Figure 1: NRCS soil survey mapping in the immediate vicinity of the proposed project

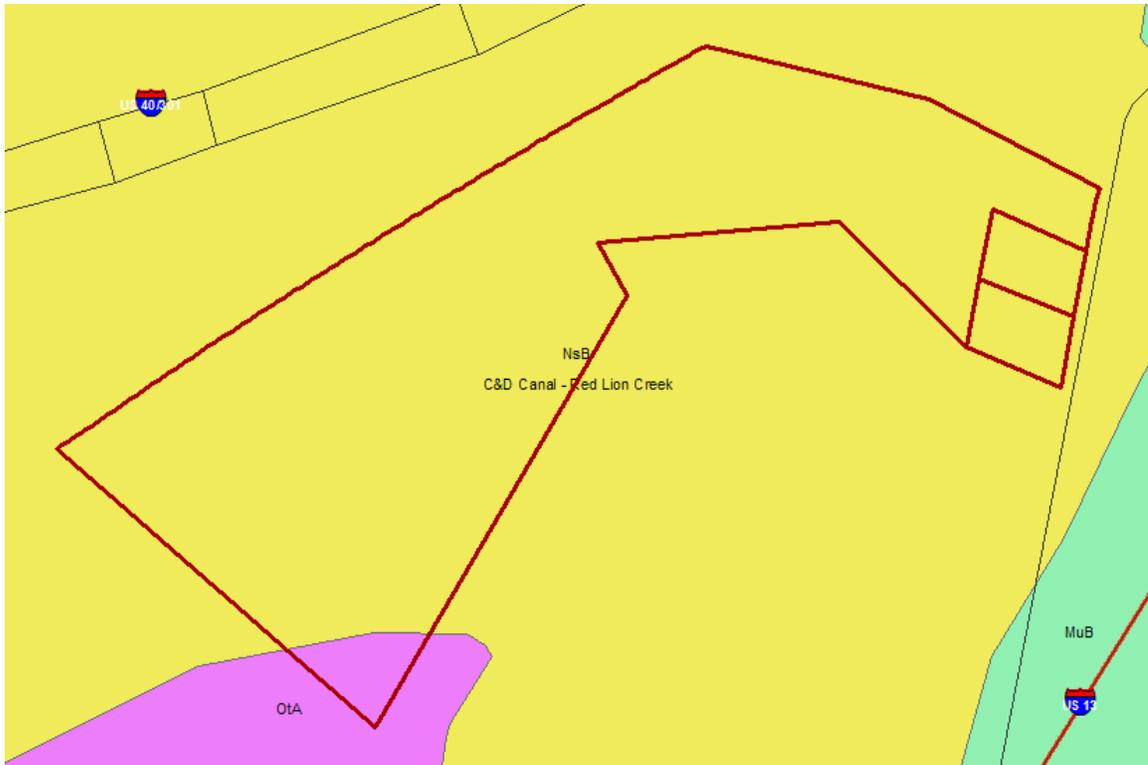
**Soils Assessment.** We strongly recommend that the applicant avoid soils mapped as Othello (OtA; See figure 1). These soils are poorly-drained (hydric) and suggestive of wetland conditions. Building in such soils is likely to leave prospective residents of this and adjoining properties susceptible to future flooding problems from groundwater-driven surface water ponding, especially during extended periods of high-intensity rainfall events such as tropical storms/hurricanes or “nor’easters.” This is in addition to the increased probability of flooding due to or increased surface water runoff emanating from future created or constructed forms of structural imperviousness (e.g., rooftops, roads, parking areas, sidewalks, and stormwater management structures).
